Amendment Notice

Licence Number L6870/1993/12

Premises Newman Wastewater Treatment Plant

Amendment

Attachment 3: Location of infrastructure and second clarifier.

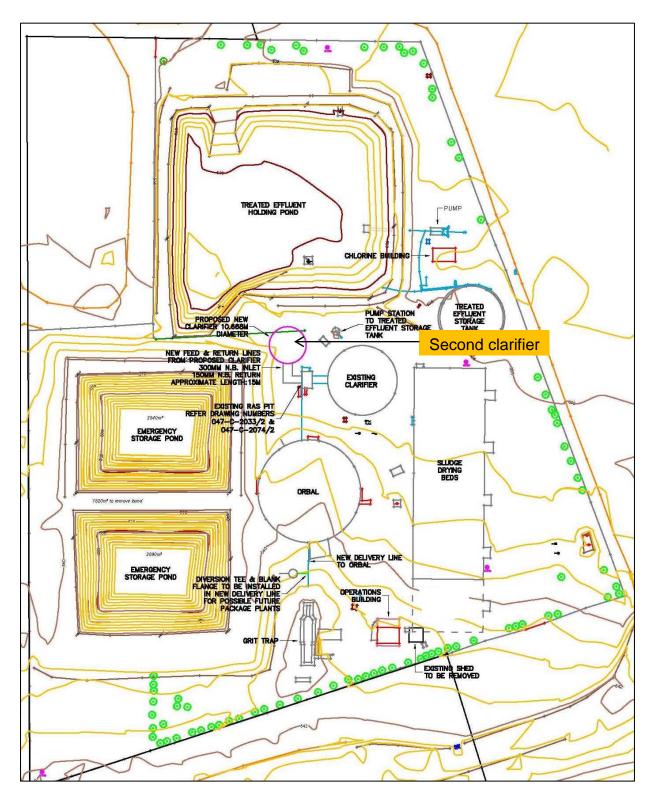
- 1. The licence is amended by the addition of condition 4(b) as follows:
 - 4(b) The Licensee shall operate the second clarifier (as shown in Attachment 3) to the following specifications:
 - (i) concrete construction and maintained in an impervious condition; and
 - (ii) the maximum flow rate to the second clarifier shall not exceed 800 kilolitres per day.

2. The licence is amended by the addition of Attachment 3 as follows:
